UNITED STATES ENVIRONMENTAL PROTECTION AGENCY

**RCRA FINAL DECISION
AND RESPONSE TO COMMENTS**

Amphenol Corporation

March 13, 2023

Figure 4

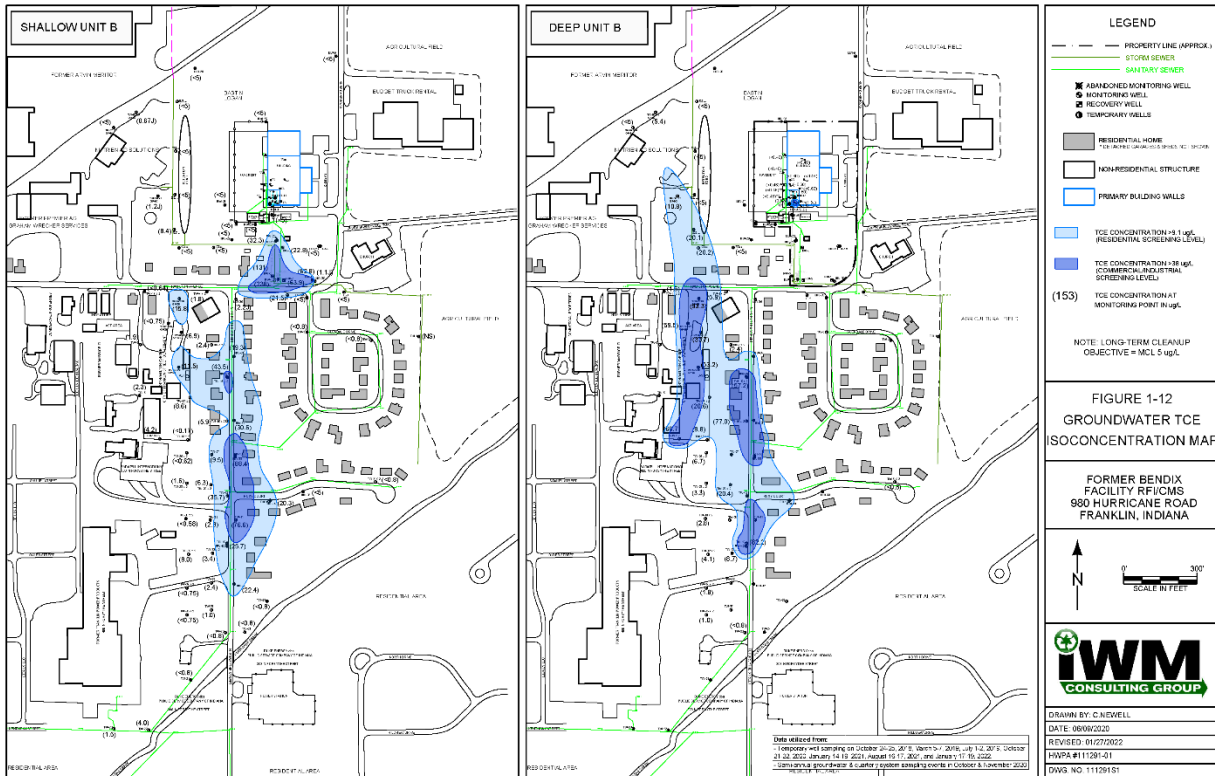
2. Comment: The current testing is not adequate, the current impacts defined may be larger, please expand the area being tested.

Response: EPA has determined the current groundwater plume, as defined in Figure 4, is supported by groundwater well results. These results give EPA confidence that the agency has accurately determined the boundaries of the plume, and therefore the edge of the plume's impacts. Groundwater wells beyond the plume boundary have been sampled and contamination levels have been found to be non-detectable. To help ensure the plume is monitored for any potential migration, continued sampling of groundwater wells will be done into the future, as defined in the Corrective Measure Implementation, or CMI, Workplan. EPA will require this workplan from the responsible parties and will complete its review after the Final Decision.

Figure 11. Treatment Plan for ISCO, ISCR and PRBs

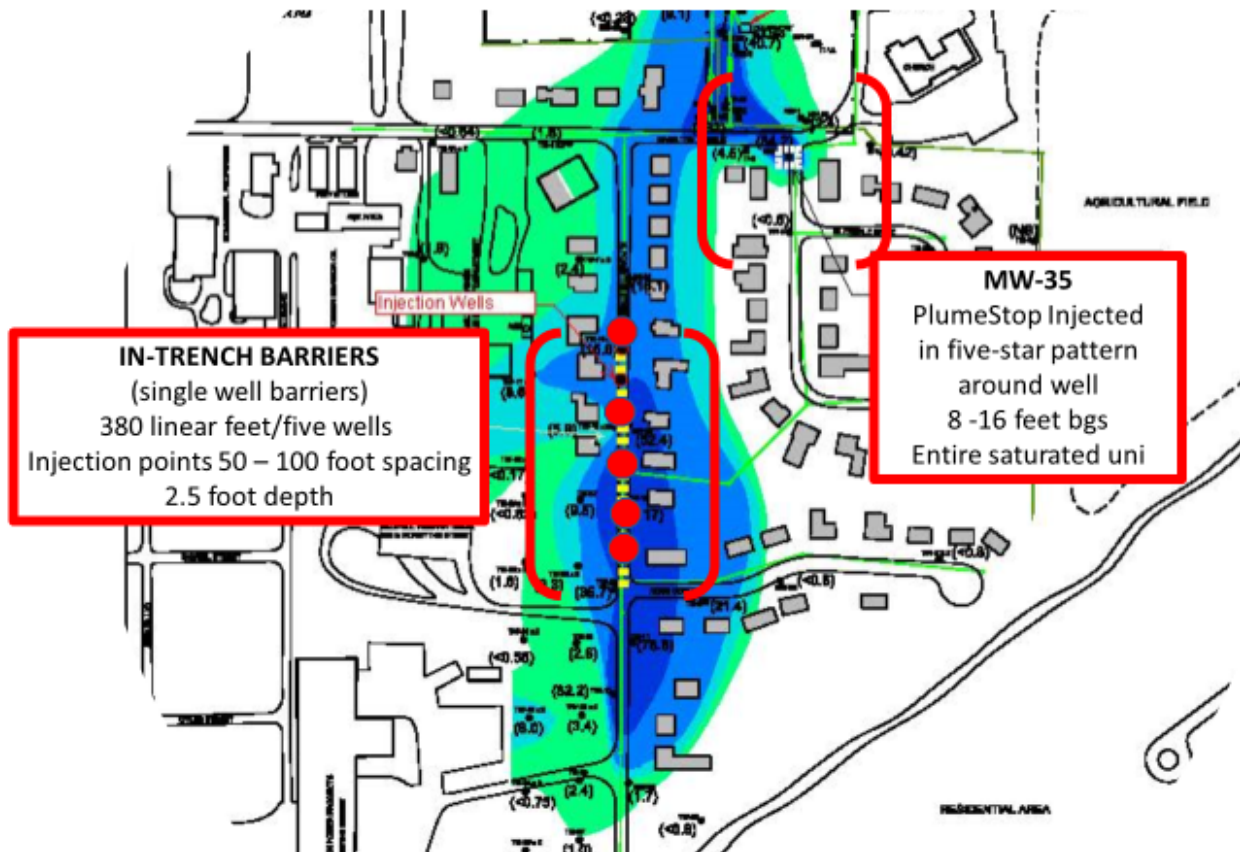
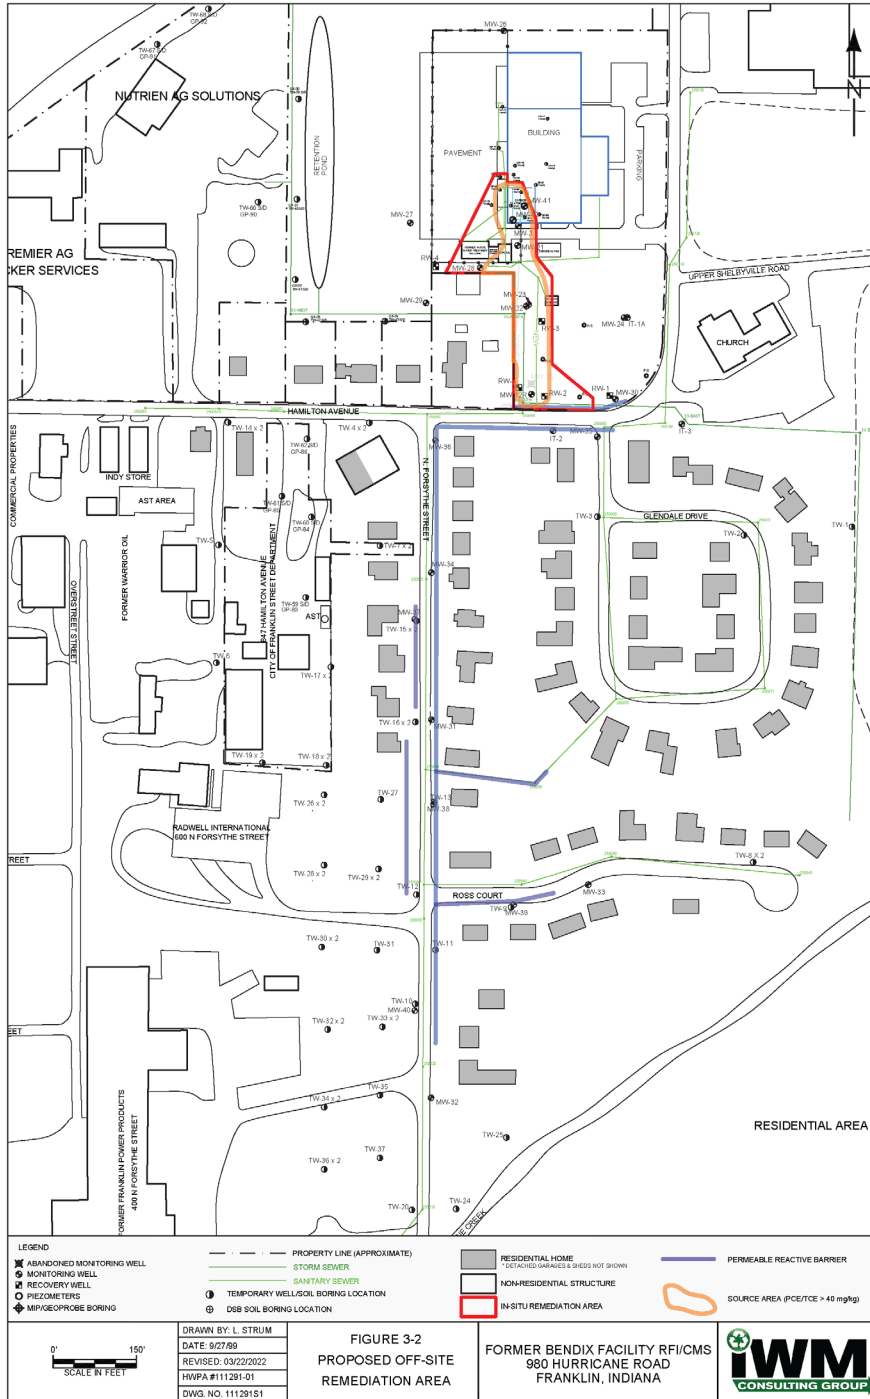
15. Comment: Off-Site PRBs are largely not oriented/aligned perpendicular to groundwater flow.

28. Comment: The Final Decision document should detail how the currently proposed injection plan will treat the entirety of the off-Site groundwater plume and adjust/add additional transects, if needed to expeditiously meet Corrective Action Objectives (CAOs).

Response: A goal of using PRBs is to chemically degrade VOCs from an upgradient source before it reaches a sensitive receptor. Pilot studies completed in preparation of the Second Supplemental Corrective Measures Study tested this technology successfully beneath the former plating room area and achieved a significant source reduction of VOCs. EPA required the responsible parties to inject PRBs on-Site and perpendicular to groundwater flow to treat groundwater before it passes through the downgradient portion of the Study Area.

When selecting the PRB lines of injections off-Site, there is a balance between access for the injections and proximity to the plume. Due to access limitations, the PRB is running north to south along Forsythe Avenue in the public right of way. To enhance capture, there are some potential portions of the PRBs perpendicular to Forsythe on private property, which EPA may add in the CMI Plan if access is granted. Although certain off-Site PRBs are not largely aligned perpendicular to groundwater flow, when combined with monitoring and additional injections as necessary, the PRB proposed locations are protective of human health and the environment and are a proven option to remediate groundwater in accordance with short-term and long-term CAOs.

Response: Others have the same concerns about the PRB placement in relation to the plume to be treated and the effectiveness of the remediation. As referenced in the response to Comment #15 above, when selecting the PRB lines of injections, there is a balance between access for the injections and proximity to the plume. Due to access limitations, the PRB is running north to south along Forsythe Avenue in the public right of way. To enhance capture, there are some potential portions of the PRBs perpendicular to Forsythe on private property, which EPA may add in the CMI Work Plan if access is granted. See Response #15. In addition, EPA may adjust or add injections to portions of the plume west of Forsythe in the CMI Work Plan; these changes will help attain CAOs in a timely manner. Assessment of any changes or optimization of PRB locations will be included in the CMI Workplan.
